MODIFICATION BULLETIN

91. 6/1

91
Safir

Power plant: Modification of the exhaust manifold

524311 Exhaust manifold

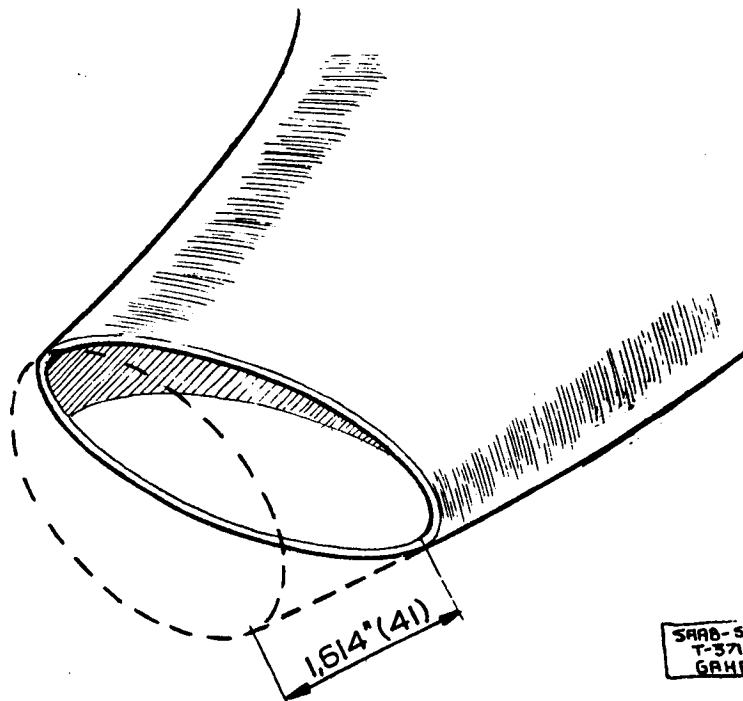
The reverse pressure of the exhaust manifold has proved to be too great, and therefore during the exhaust stroke No. 4 cylinder will not be adequately cleaned. For this reason the outlet area of the exhaust manifold should be increased by oblique cutting according to the figure below:
